**ST. LUCIE PLANT
UNIT 1 AND UNIT 2**

**IMPROVED TECHNICAL
SPECIFICATIONS CONVERSION**

**ITS CHAPTER 2.0
SAFETY LIMITS**

**Current Technical Specifications (CTS) Markup
and Discussion of Changes (DOCs)**

FIGURE 2.1-1: REACTOR CORE THERMAL MARGIN SAFETY LIMIT - ~~FOUR REACTOR COOLANT PUMPS OPERATING~~

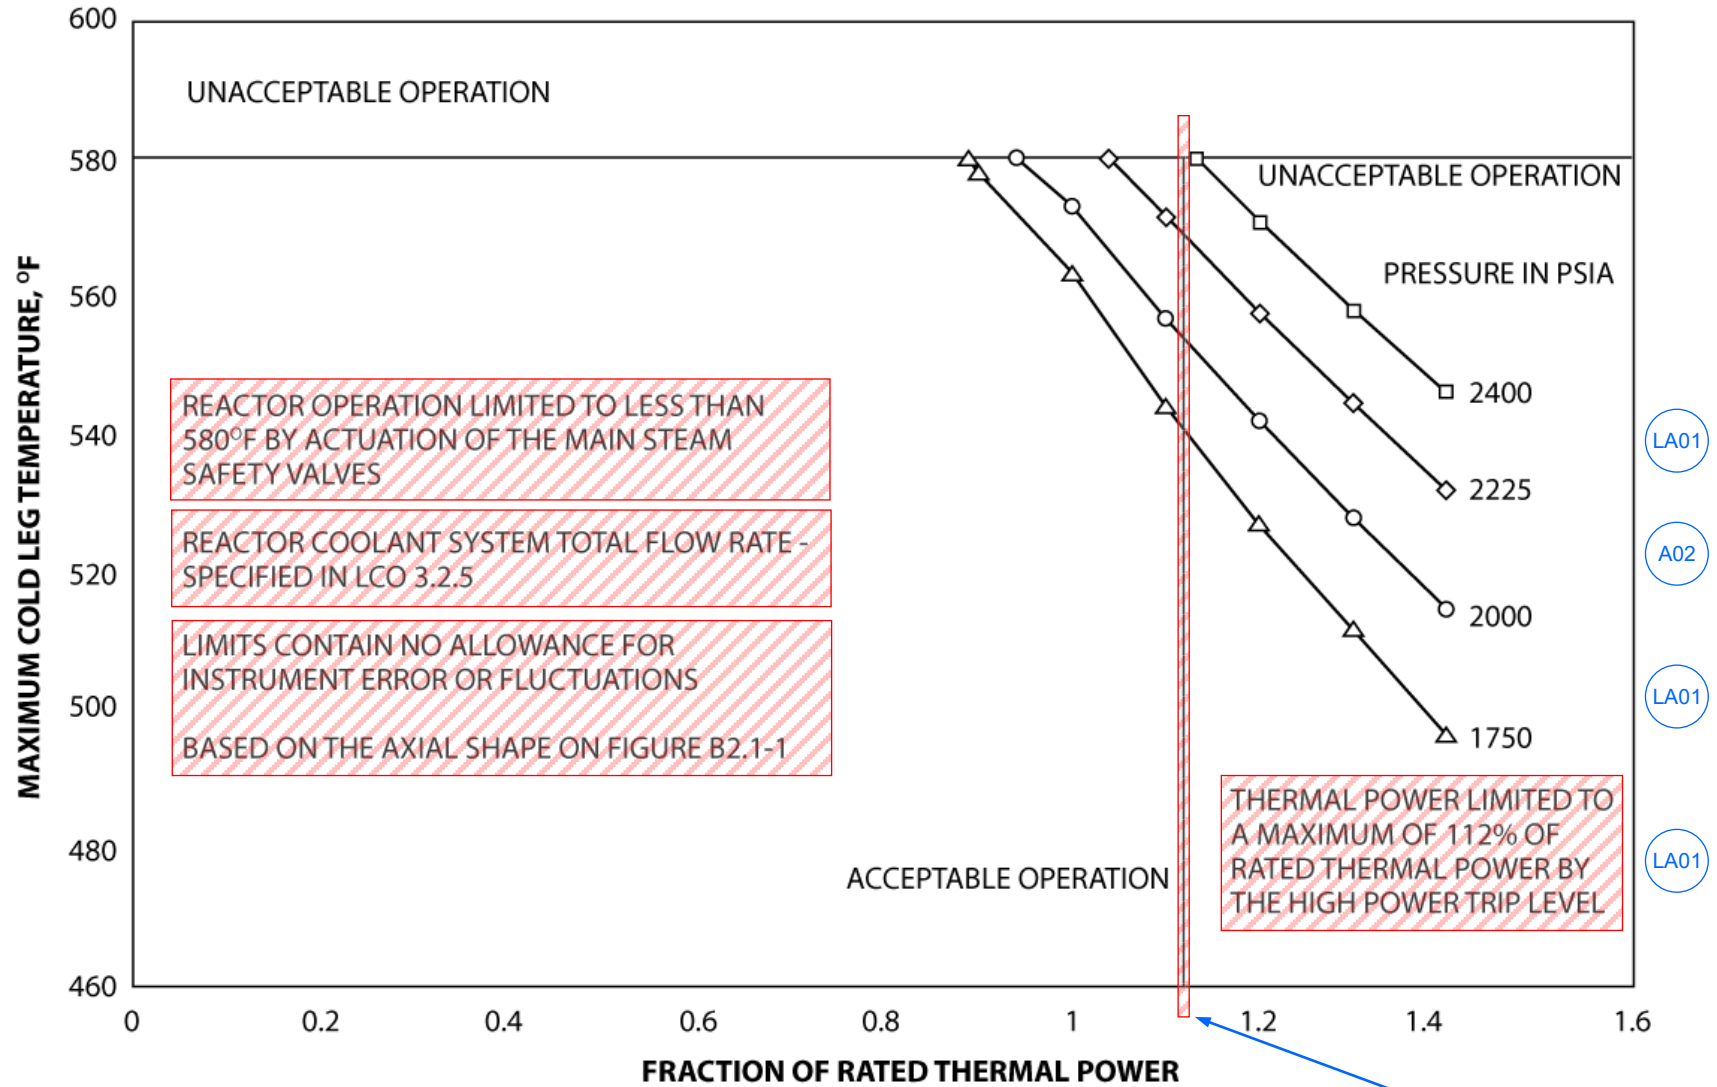
- A02 **Unit 1 only:** CTS Figure 2.1-1 states "Reactor Coolant System total flow rate – specified in LCO 3.2.5." ITS Figure 2.1.1-1 does not contain the statement. This changes the CTS by not including a cross reference to the equivalent reference ITS 3.4.1, "RCS Pressure, Temperature, and Flow Departure from Nucleate Boiling (DNB) Limits," which contains the Reactor Coolant System total flowrate. This change is acceptable because the CTS Figure 2.1-1 detail used to alert the user that the Reactor Coolant System total flowrate is covered under a separate LCO requirement is an unnecessary presentation preference. ITS does not include information only type of cross references to other Specifications. ITS Figure 2.1.1-1, Reactor Core Thermal Margin Safety Limit , is retained without the cross reference detail.

- A03 PSL Unit 1 CTS Figure 2.1-1, Reactor Core Thermal Margin Safety Limit – Four Reactor Coolant Pumps Operating contains an operational limit line showing thermal power limited to a maximum of 112% of RATED THERMAL POWER by the High Power Trip. PSL Unit 2 CTS Figure 2.1-1, Reactor Core Thermal Margin Safety Limit – Four Reactor Coolant Pumps Operating contains an operational limit line showing thermal power limited to a maximum of 107% of RATED THERMAL POWER by the High Power Level Trip, and contains an operational limit line showing limits on maximum cold leg temperature due to secondary safety valve actuation. Additionally, the Unit 1 and Unit 2 figure titles include the statement "Four Reactor Coolant Pumps Operating."

The RPS operational limit line is removed from the Unit 1 and Unit 2 figures. This operational limit could be violated during a transient; however, it does not necessarily mean the reactor core SL was violated. Removing the operational limit line shifts the unacceptable area to the actual SL limits based on RCS pressure lines. The RPS operational limit is provided in the ITS Bases. The figure title text "Four Reactor Coolant Pumps Operating" is deleted from the Unit 1 and Unit 2 figures. Unit 1 and Unit 2 only operate with four reactor coolant pumps. Therefore, this text is deleted for consistency with ISTS Figure 2.1.1-1 title. The operational limit line showing limits on maximum cold leg temperature due to secondary safety valve actuation is removed from the Unit 2 figure. This operational limit could be violated during a transient; however, it does not necessarily mean the reactor core SL was violated. Removing this operational

limit line shifts the unacceptable area to the actual SL limits based on RCS pressure lines.

- LA01 (*Type 1 – Removing Details of System Design and System Description, Including Design Limits*) CTS 2.1.1 states “The combination of THERMAL POWER, pressurizer pressure, and maximum cold leg coolant temperature shall not exceed the limits shown on Figure 2.1-1.” ITS states “The combination of THERMAL POWER, pressurizer pressure, and the highest operating loop cold leg coolant temperature shall not exceed the limits shown in Figure 2.1.1-1.” This changes the CTS by moving details shown on the CTS Figure 2.1-1 to the ITS Bases.

PSL Unit 1 CTS Figure 2.1-1 statements “Reactor operation limited to less than 580°F by actuation of Main Steam Safety Valves”, “Limits contain no allowance for instruments error or fluctuations”, “Based on the Axial Shape Index on Figure B 2.1-1,” and “THERMAL POWER limited to a maximum of 112% of RATED THERMAL POWER by the high power trip level” are moved from the Technical Specifications to the ITS Bases. The line showing THERMAL POWER at 112%

is deleted. The Reactor Core Safety Limits are retained in Technical Specification Chapter 2.0.

This change is designated as administrative as it incorporates an ITS convention to remove superfluous lines not directly related to violation of the safety limit with no technical change.

FIGURE 2.1-1: REACTOR CORE THERMAL MARGIN SAFETY LIMIT LINES
FOUR REACTOR COOLANT PUMPS OPERATING

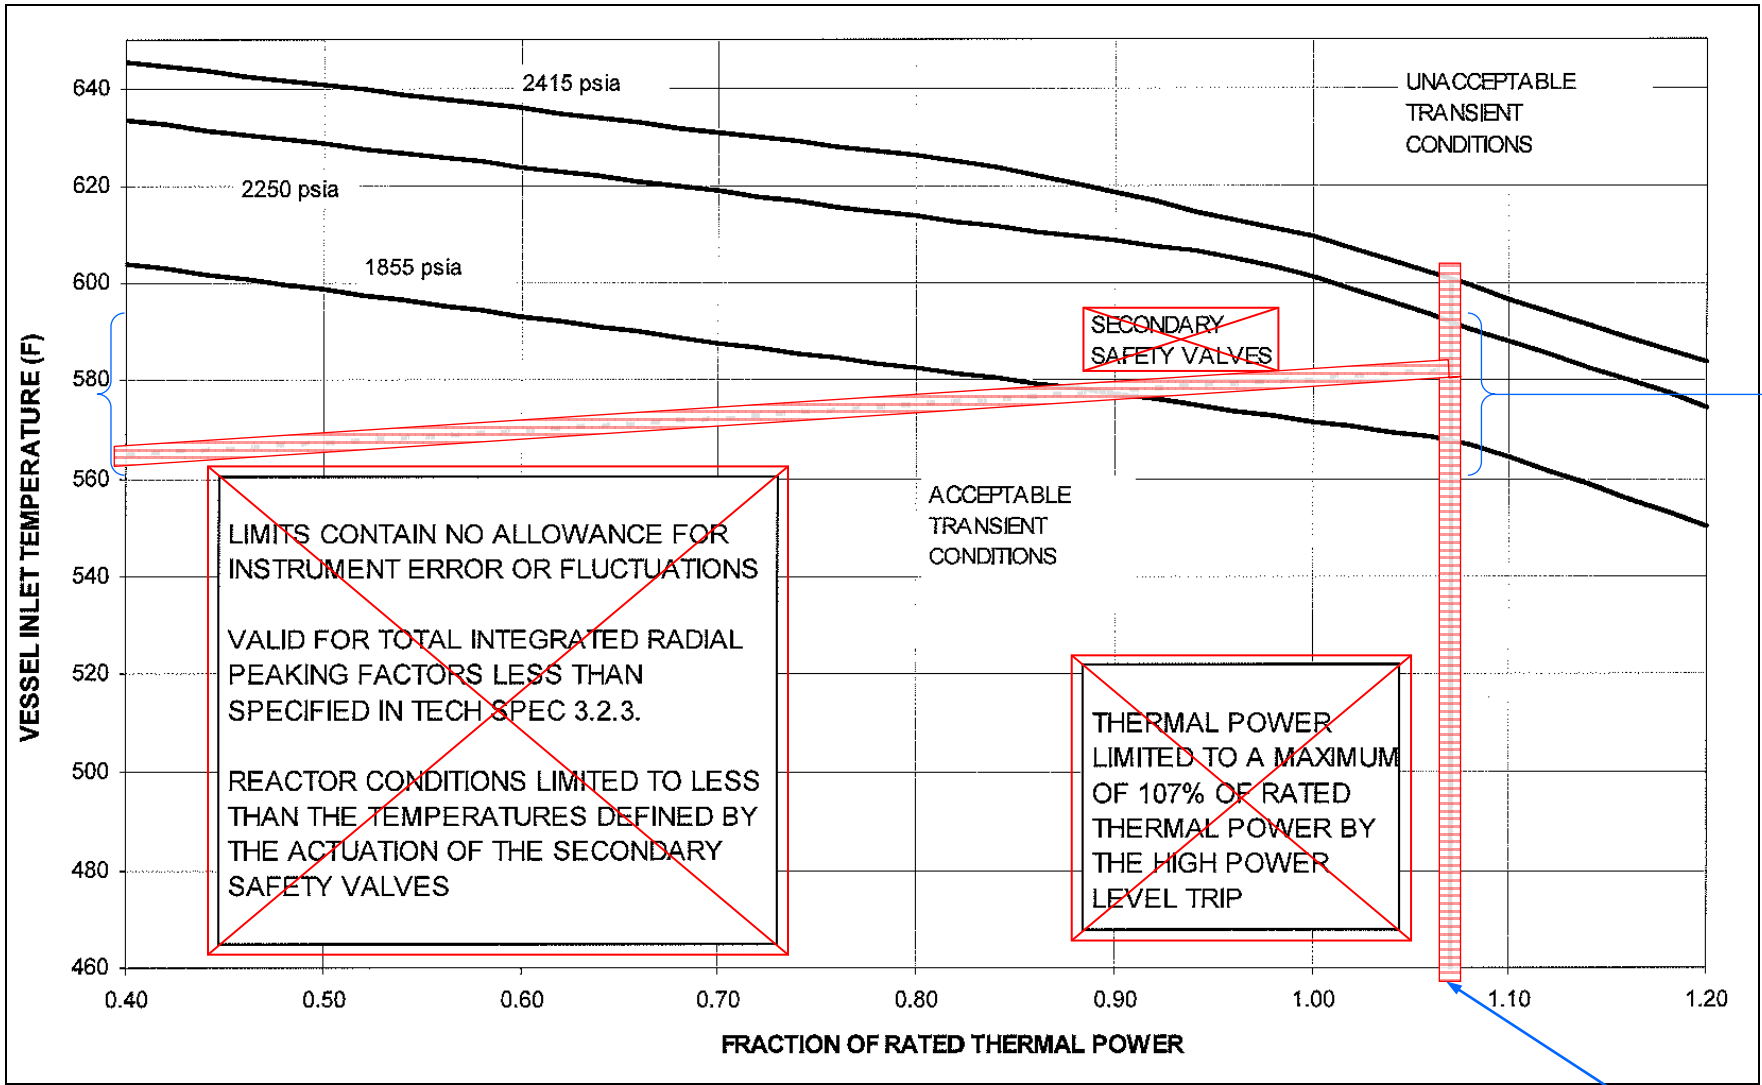
PSL Unit 2 CTS Figure 2.1-1 statements “Reactor Conditions limited to less than the temperatures defined by the actuation of the secondary safety valves”, “Limits contain no allowance for instruments error or fluctuations”, “Valid for Total Integrated Radial Peaking Factors less than specified in Tech Spec 3.2.3” and “THERMAL POWER limited to a maximum of 107% of RATED THERMAL POWER by the high power level trip” are moved from the Technical Specifications to the ITS Bases. The Reactor Core Safety Limits are retained in Technical Specification Chapter 2.0.

Figure 2.1.1-1 (page 1 of 1)
Reactor Core Thermal Margin Safety Limit

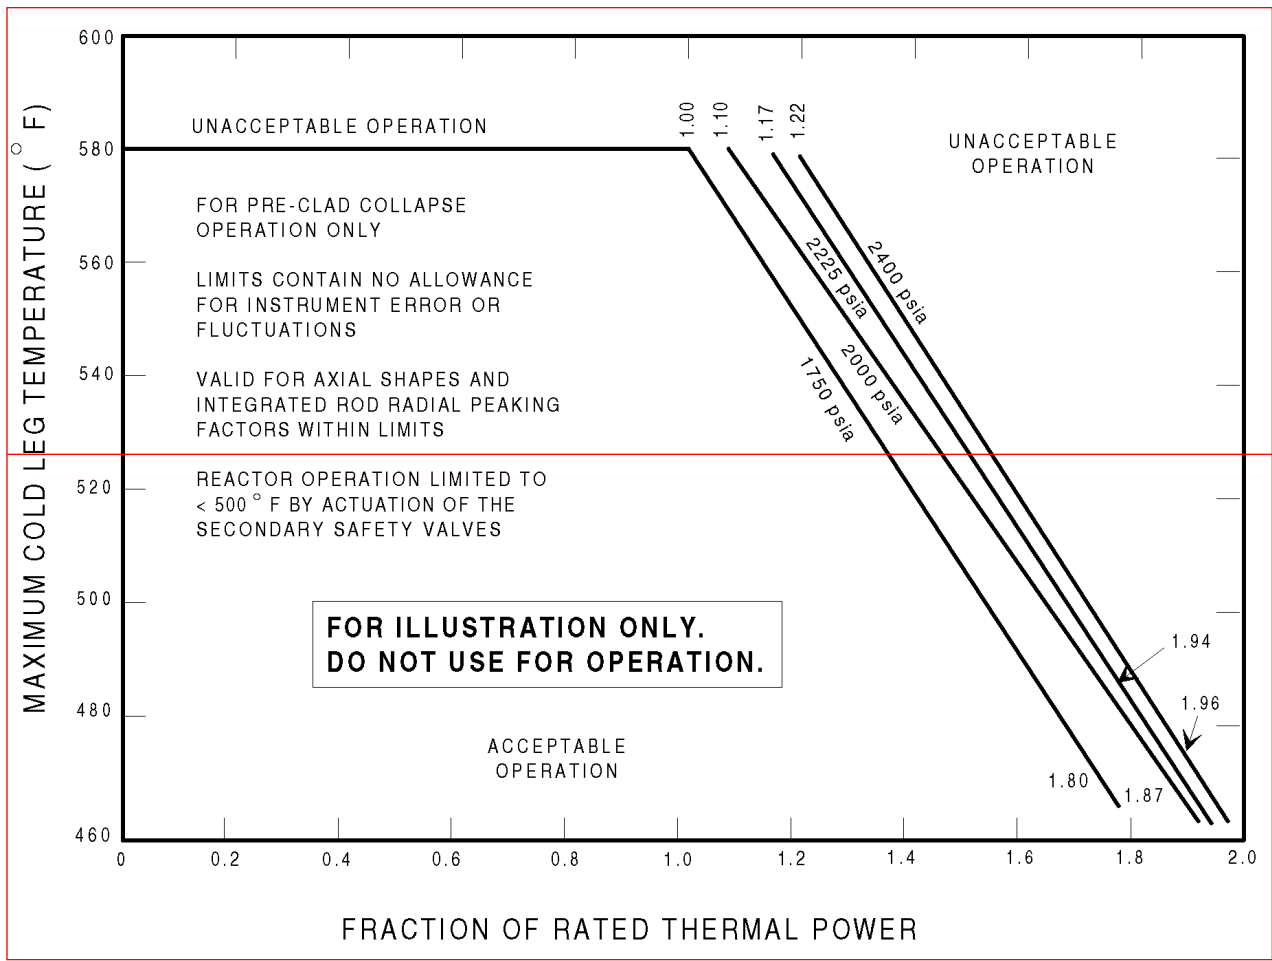
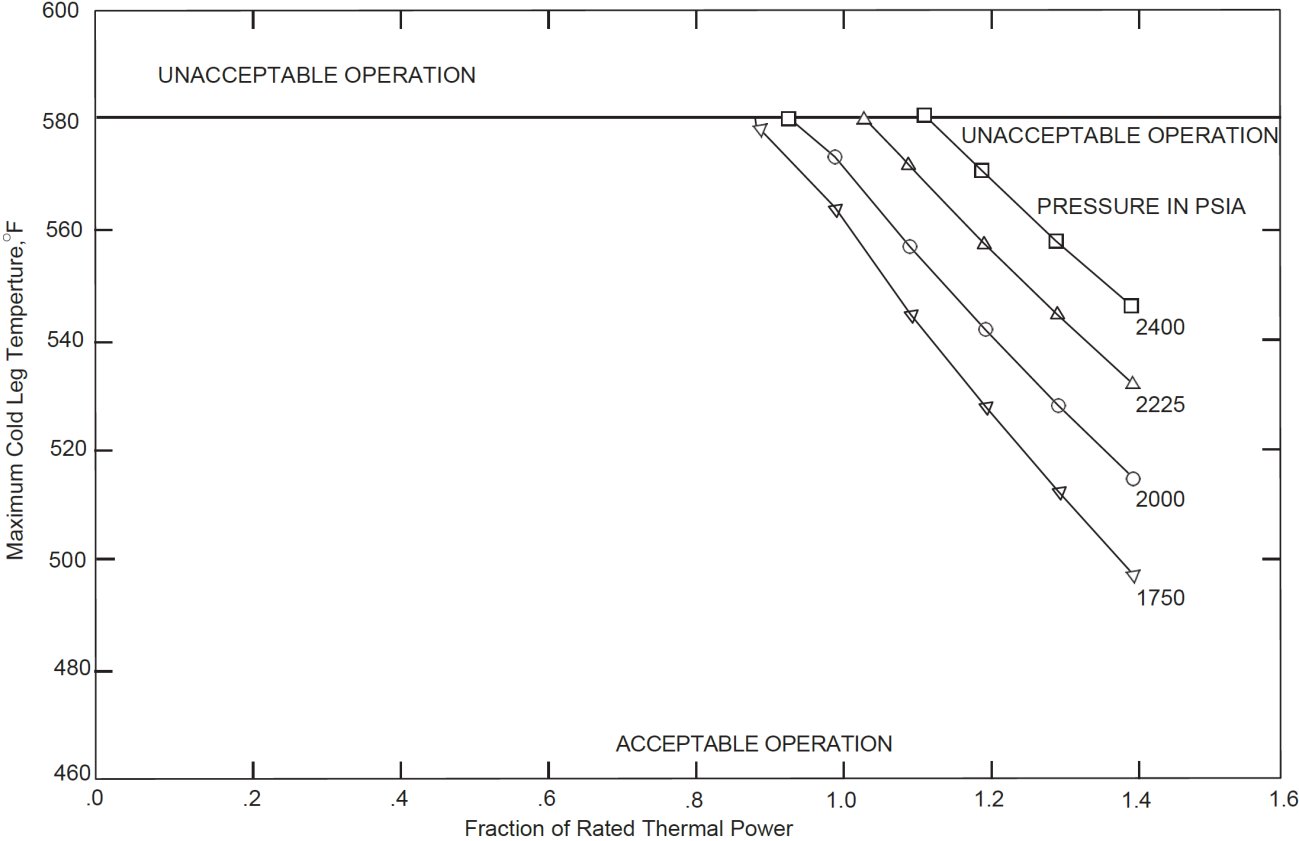
3. Grammatical error is corrected. Double spacing between sentences and single spacing between words. Single spacing is corrected.
4. CTS Figure 2.1-1 contained details that are moved to the Bases. The details are added to the ITS Figure 2.1.1-1 Bases. See DOC LA01.
